Illinois Tollway Standard Drawing Revisions

| Section C | Guardrail & Concrete Barrier | | | |
| | Standard | Modification Summary Effective: 03-01-2023 | | |

| | | Illinois Tollway |
|-----------|---------------------------------|-------------------------|
| 3-31-2016 | ADDED MAX. EXPOSED BASE, | STANDARD C3-10 |

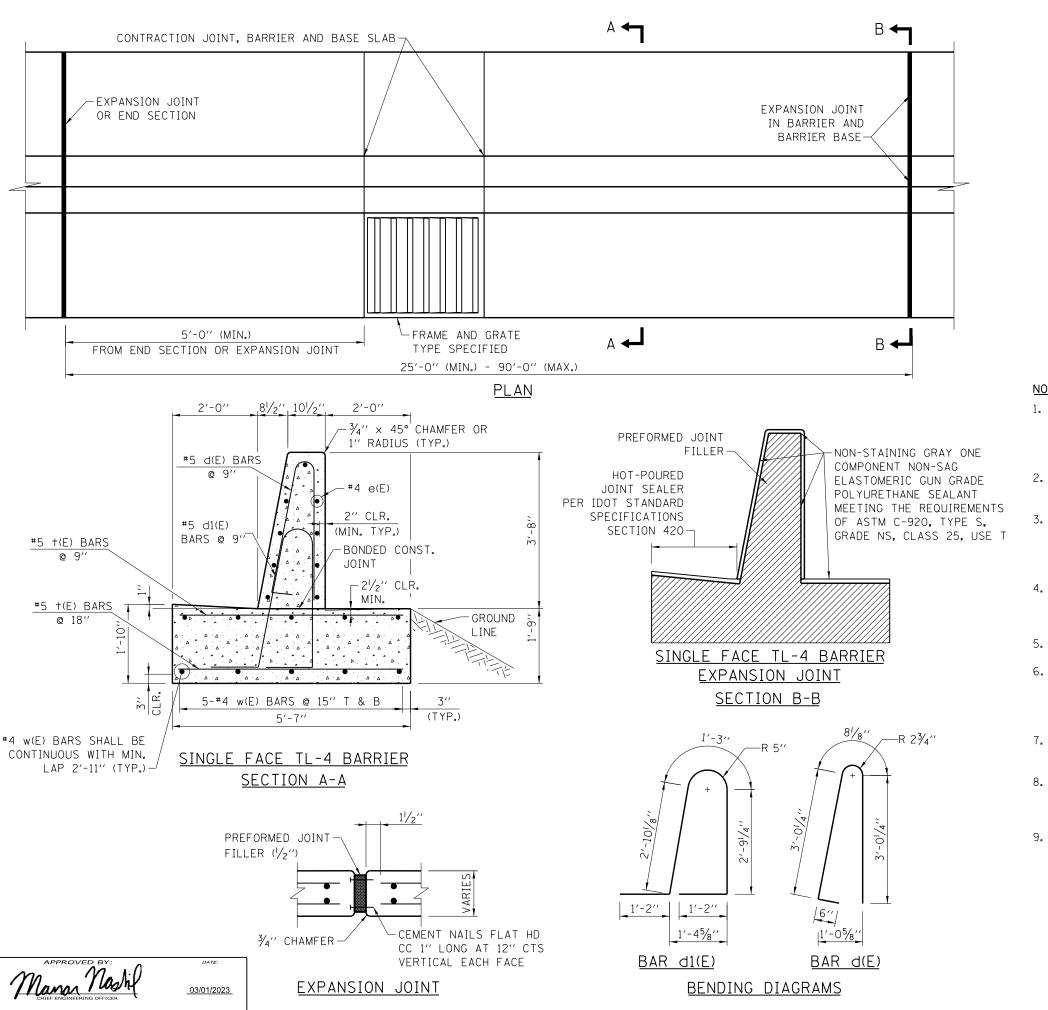
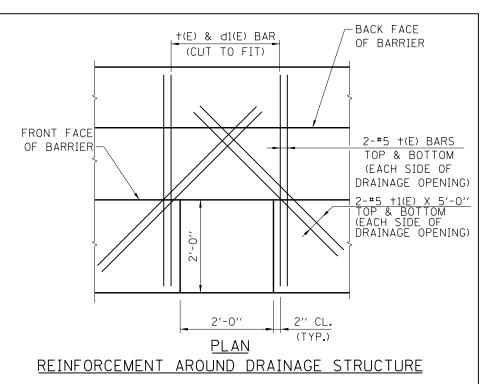
| Section C | Guardrail & Concrete Barrier | | | |
|-----------|------------------------------|--|--------|--|
| | C3-10 | CONCRETE BARRIER SINGLE FACE, REINFORCED TL-4, 44 INCH | | |
| | | Revised detail, reinforcement around drainage structure. | | |

| | | Illinois Tollway |
|-----------|---------------------------------|-------------------------|
| 3-01-2023 | REVISED REINF. AT DRAINAGE STR. | FACE. REINFORCED |

- 7. AT DRAINAGE STRUCTURES, CUT FOOTING BARS TO FIT. ADD ADDITIONAL + AND +1 BARS ON EACH SIDE OF THE DRAINAGE STRUCTURE.
- 8. EXPANSION JOINTS SHALL BE CONSTRUCTED IN BARRIER WALL AT A MAXIMUM JOINT SPACING OF 90'-0" AND A MINIMUM JOINT SPACING OF 25'-0". SEE SECTION B-B FOR DETAILS.

| | | Illinois Tollway |
|-----------|-----------------------------------|--|
| DATE | REVISIONS | CONCRETE BARRIER SINGLE FACE, REINFORCED TL-5, T-SHAPE 44 INCH |

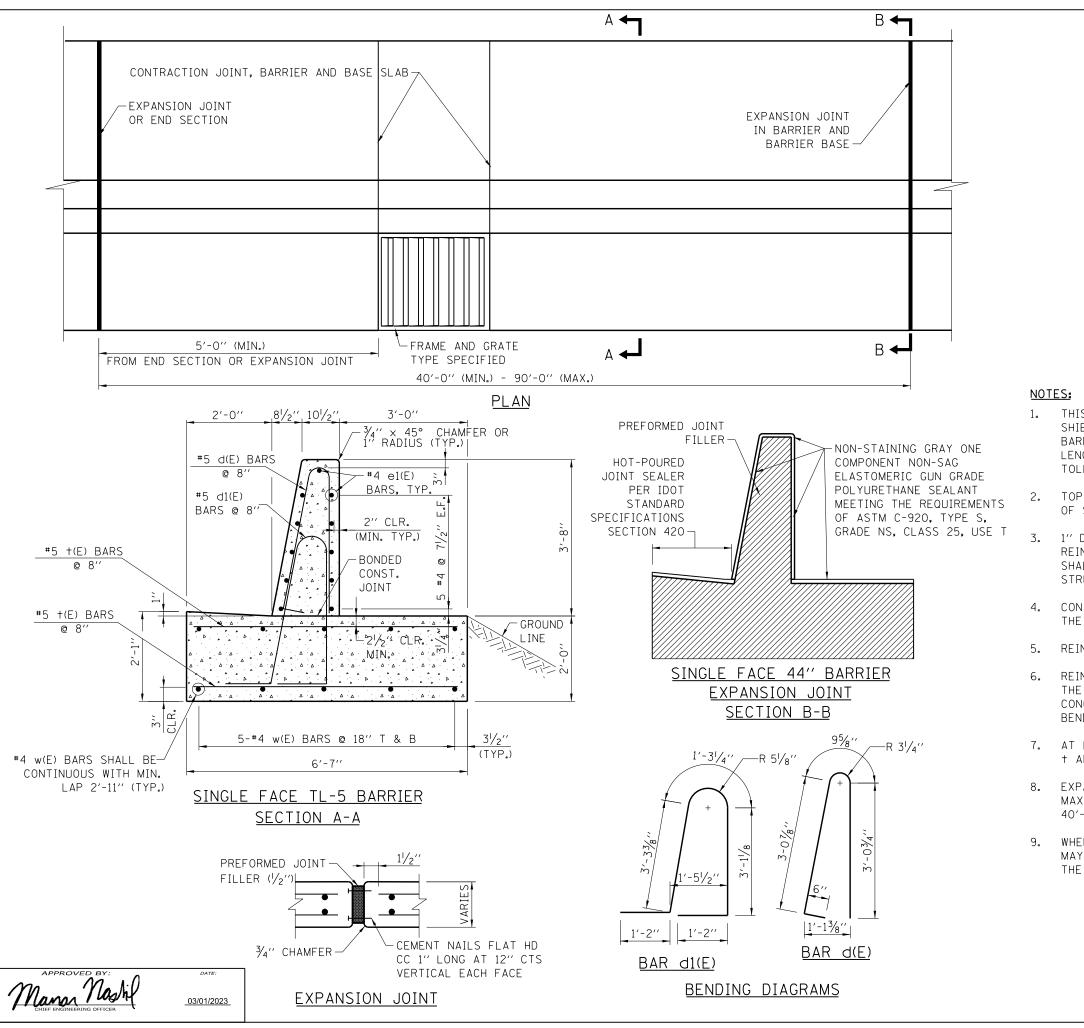
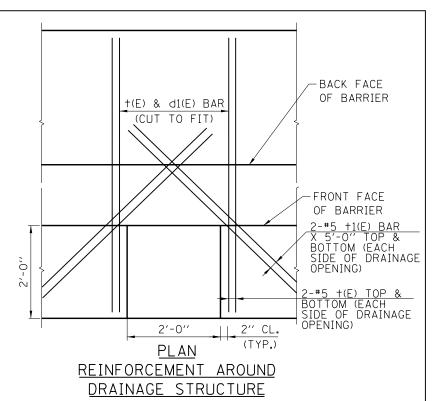
| Section C | Guardrail & Concrete Barrier | | | |
|-----------|------------------------------|--|--------|--|
| | C15-03 | CONCRETE BARRIER SINGLE FACE, REINFORCED TL-5, T-SHAPE 44 INCH | | |
| | | Revised Note #1 and the reinforcement around drainage structure detail. | | |

| | | Illinois Tollway |
|-----------|-----------------------------------|--|
| 3-01-2023 | REVISED NOTE #1 AND REINF. DETAIL | |
| | AT DRAINAGE STRUCTURES | |

- THIS IS A REINFORCED CONCRETE TL-5 ROADSIDE BARRIER USED TO SHIELD DROP-OFFS AND FOR PROTECTION OF STRUCTURES WHEN THE BARRIER IS AWAY FROM THE FACE OF THE STRUCTURE. THE MINIMUM LENGTH OF INSTALLATION SHALL BE 40'-O". BASIS OF DESIGN: IL TOLLWAY STRUCTURE DESIGN MANUAL.

- 7. AT DRAINAGE STRUCTURES, CUT FOOTING BARS TO FIT. ADD ADDITIONAL + AND +1 BARS ON EACH SIDE OF THE DRAINAGE STRUCTURE.
- 8. EXPANSION JOINTS SHALL BE CONSTRUCTED IN BARRIER WALL AT A MAXIMUM JOINT SPACING OF 90'-0" AND A MINIMUM JOINT SPACING OF 40'-0". SEE SECTION B-B FOR DETAILS.

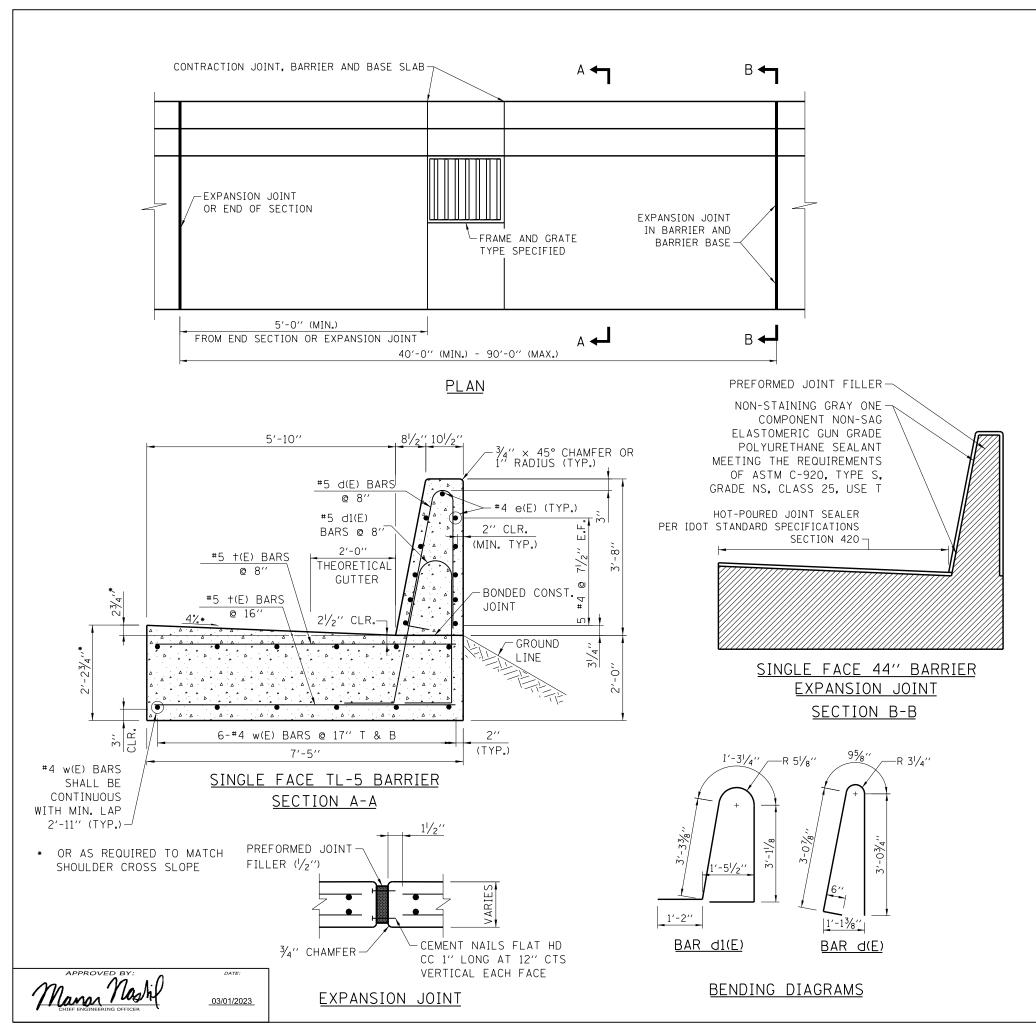
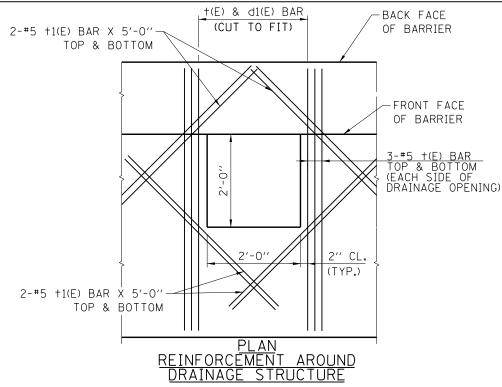
| Section C | Guardrail & Concrete Barrier | | | |
|-----------|------------------------------|--|--------|--|
| | C16-03 | CONCRETE BARRIER SINGLE FACE, REINFORCED TL-5, L-SHAPE 44 INCH | | |
| | | Revised Note #1 and the reinforcement around drainage structure detail. | | |

- 1. THIS IS A REINFORCED CONCRETE TL-5 ROADSIDE BARRIER USED TO SHIELD DROP-OFFS AND FOR PROTECTION OF STRUCTURES WHEN THE BARRIER IS AWAY FROM THE FACE OF THE STRUCTURE. THE MINIMUM LENGTH OF INSTALLATION SHALL BE 40'-0". BASIS OF DESIGN: IL TOLLWAY STRUCTURE DESIGN MANUAL.

- 7. AT DRAINAGE STRUCTURES, CUT FOOTING BARS TO FIT. ADD ADDITIONAL + AND +1 BARS ON EACH SIDE OF THE DRAINAGE STRUCTURE.
- 8. EXPANSION JOINTS SHALL BE CONSTRUCTED IN BARRIER WALL AT A MAXIMUM JOINT SPACING OF 90'-0". AND A MINIMUM JOINT SPACING OF 40'-0". SEE SECTION B-B FOR DETAILS.
